Addendum 54 – Regulation No. 55

Revision 2 - Amendment 1

Supplement 5 to the 01 series of amendments – Date of entry into force: 8 October 2016

Uniform provisions concerning the approval of mechanical coupling components of combinations of vehicles

Figure 25 a

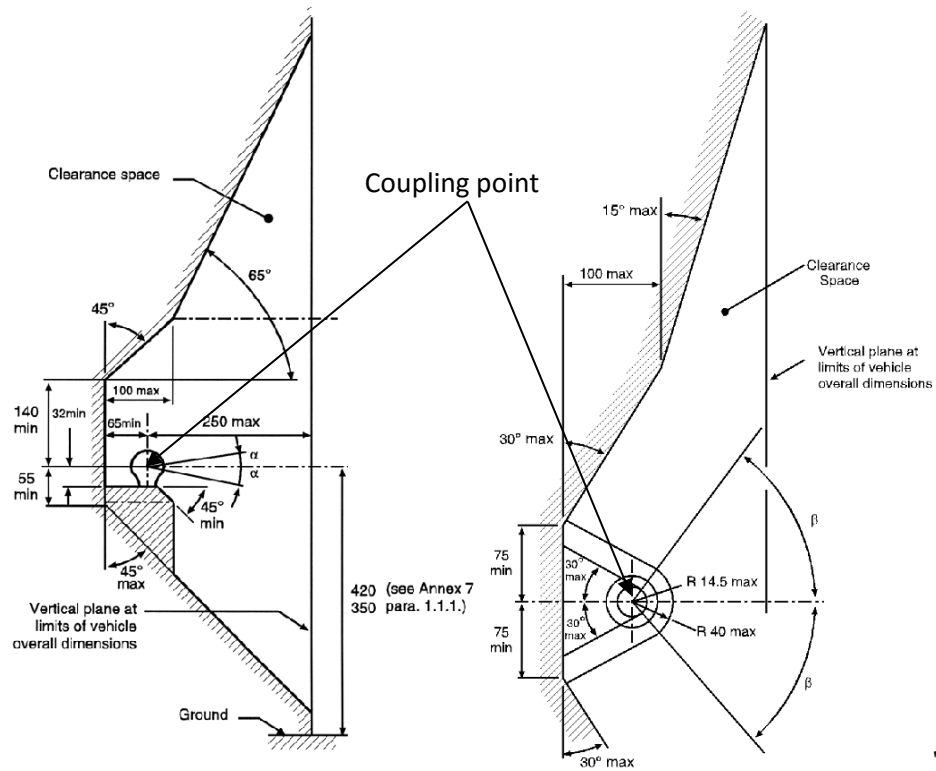
Paragraph 1.1., amend to read:

- "1.1. Attachment of coupling balls, hook couplings and towing brackets
- 1.1.1. Coupling balls, hook coupling and towing brackets shall be attached to vehicles of categories M₁, M₂ (below 3.5t maximum permissible mass) and N₁ in a manner which conforms to the clearance and height dimensions given in Figure 25. The height shall be measured at the vehicle loading conditions given in Appendix 1 to this annex.

- 1.1.1.1. The clearance space shown in Figures 25a and 25b may be occupied by non-demountable equipment, such as a spare wheel, provided that the distance from the centre of the ball or the centre of the hook on a vertical plane at the extreme rearmost point of the equipment does not exceed 250 mm. The equipment shall be mounted to allow adequate access for coupling and uncoupling without risk of injury to the user and without affecting articulation of the coupling.

- is rotated horizontally 60° to right or left, ($\beta = 60^\circ$, see Figure 25);
 - is rotated vertically 10° up or down ($\alpha = 10^\circ$, see Figure 25);

- 1.2.2. It shall be possible to operate the coupling heads/ toroidal drawbar eyes safely within the free space of the coupling ball/hook coupling given in figures 25a and 25b, up to angles of $\alpha = 25^\circ$ and $\beta = 60^\circ$.
